Service Kit 759-3960

CODE: R-457

Date: December 08, 2000

Subject: Adjustment Lift Links

FIGURE A

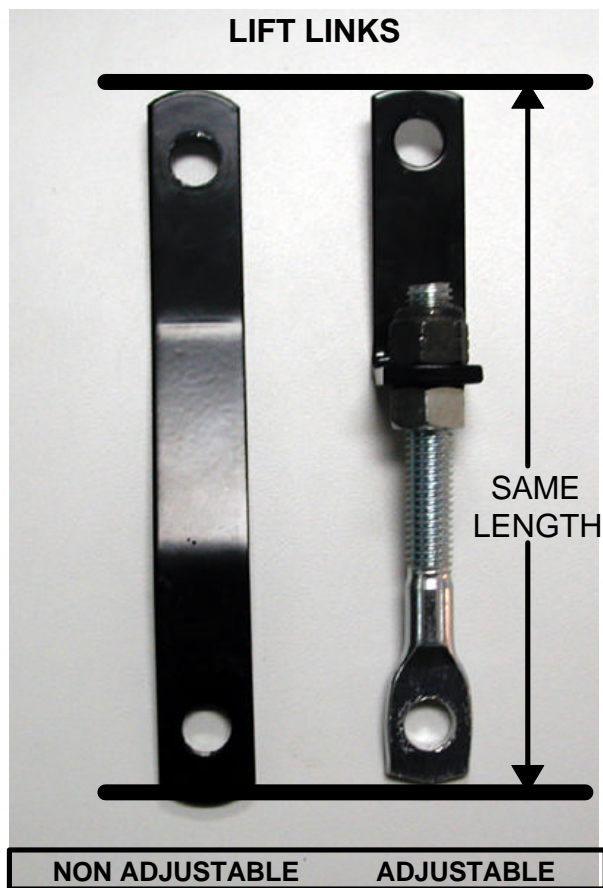
Use this kit to change non adjustable lift links to adjustable lift links.

FIGURE B

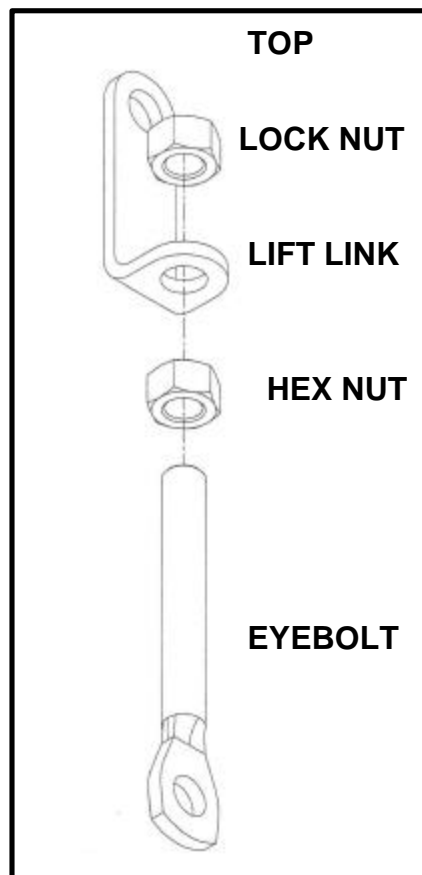
- With the snow thrower lowered to the ground, remove the left and right non adjustable lift links and retain the hardware. Assemble the new adjustable lift links with the parts supplied in the kit as follows. See Figure B. Thread one hex nut most of the way up on each eyebolt, then insert each eyebolt through the hole of each link as shown in Figure A. Secure each link with nylon lock nut. Place the new adjustable lift links along side the old non adjustable lift links. Adjust each eyebolt, equally, until the new lift link is the same length as the old lift link. Install the adjustable lift link onto each side of the snow thrower using the hardware previously removed. Loosen or tighten the nuts on the adjustable lift links as necessary to level the snow thrower side to side.

- If the drive shaft is contacting the muffler shield, loosen the top lock nuts and tighten the bottom hex nuts on each eyebolt to allow clearance between the drive shaft and the muffler shield.
